DOE/Sandia Responses to NMED's

"Notice of Disapproval: Monitoring Well Plug and Abandonment Plan and Replacement Well Construction Plan Decommissioning of Groundwater Monitoring Well TAV-MW1, Installation of Replacement Groundwater Monitoring Well TAV-MW10, April 20, 2007"

**Monitoring Well Plug and Abandonment Plan
and
Replacement Well Construction Plan**

Revision 1

Figure 1
Location of TAV-MW1 and Proposed Well TAV-MW10

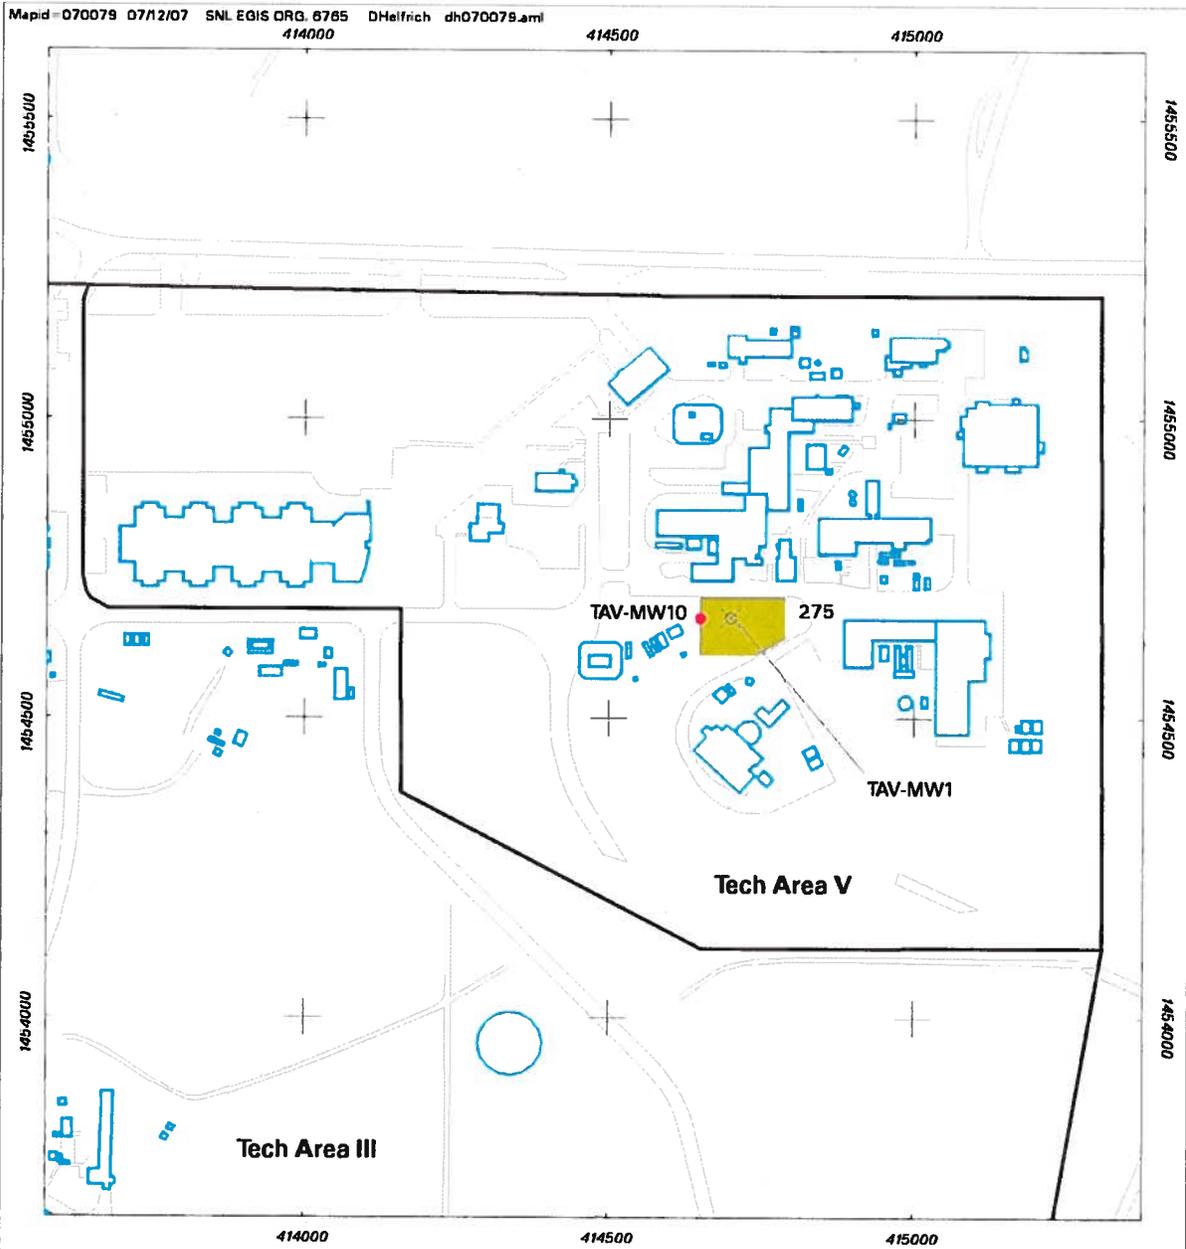
1. Page 5, Section 5.1 – This section states that TAV-MW10 will be installed a minimum of 25 feet away from the existing well (TAV-MW1) location and that the actual location will be selected with concurrence from NMED personnel. The proposed location for TAV-MW10 as shown on Figure 1 is not acceptable to the NMED, as the distance from the existing well is too great. A location no more than 30 feet from TAV-MW1 would be acceptable to the NMED. Modify the plan to indicate the location of TAV-MW10 is to be within 30 feet of TAV-MW1.

Response: It is the intent of DOE/Sandia to install a replacement well as close as practical to the original well. However, deviation logs for existing wells in the vicinity of TA-III and TA-V show that the bottom of a 500+ foot (ft) deep well can commonly be located 20+ ft away (in map view) from the surface completion. To prevent potentially intersecting the existing well DOE/Sandia would prefer to install a replacement well 50 ft away. The shape of the trichloroethene plume in TAV groundwater is well established and relatively stable, such that a replacement well 50 ft away from TAV-MW1 will consistently represent groundwater in this portion of the plume. To further complicate the placement of well TAV-MW10, this portion of TA-V is highly industrialized with a large number of above-ground and underground utilities, and structures that may dictate the location of the well.

With these considerations in mind, this section of the revised *“Monitoring Well Plug and Abandonment Plan and Replacement Well Construction Plan, Decommissioning of Groundwater Monitoring Well TAV-MW1, Installation of Replacement Groundwater Monitoring Well TAV-MW10, Revision 1”* (hereafter referred to as the plan) has been changed and now reads: “TAV-MW10 will be installed at a location approximately 50 ft away from TAV-MW1 (Figure 1), with the precise location determined in the field based on the location of existing above-ground and underground utilities, and structures.”

In addition, the location of TAV-MW10 on Figure 1 has been changed to schematically represent a well 50 ft away from TAV-MW1. The legend of Figure 1 reflects that the precise location of TAV-MW10 will be determined in the field based on the location of existing above-ground and underground utilities, and structures.
